CITY OF AUSTIN – DEVELOPMENT SERVICES DEPARTMENT
SITE PLAN APPLICATION – MASTER COMMENT REPORT

CASE NUMBER: SP-2020-0084D
REVISION #: 00 UPDATE: U0
CASE MANAGER: Ann DeSanctis PHONE #: 512-974-3102

PROJECT NAME: AIM South Lamar C1 Riverside Dr to Barton Springs Road
LOCATION: 204 1/2 S LAMAR BLVD SB

Demolition

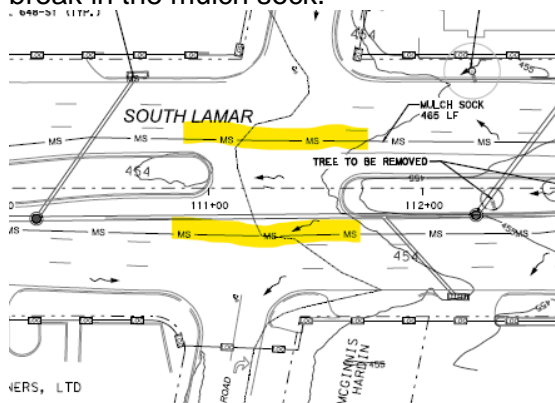
- EV 2 Add a note to the ESC plan stating:
“A preconstruction meeting with the Environmental Inspector is required prior to any site disturbance.”

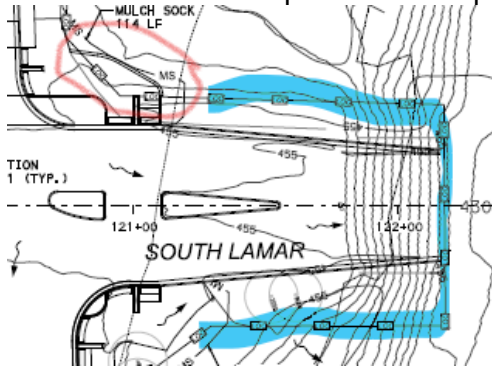
- EV 7 Clarify what work is proposed in the area of the LOC outlined in blue. Reduce the LOC to only the necessary area to accommodate proposed work. Also, in the area circled in red, it appears that the LOC does not encompass all of the proposed work.
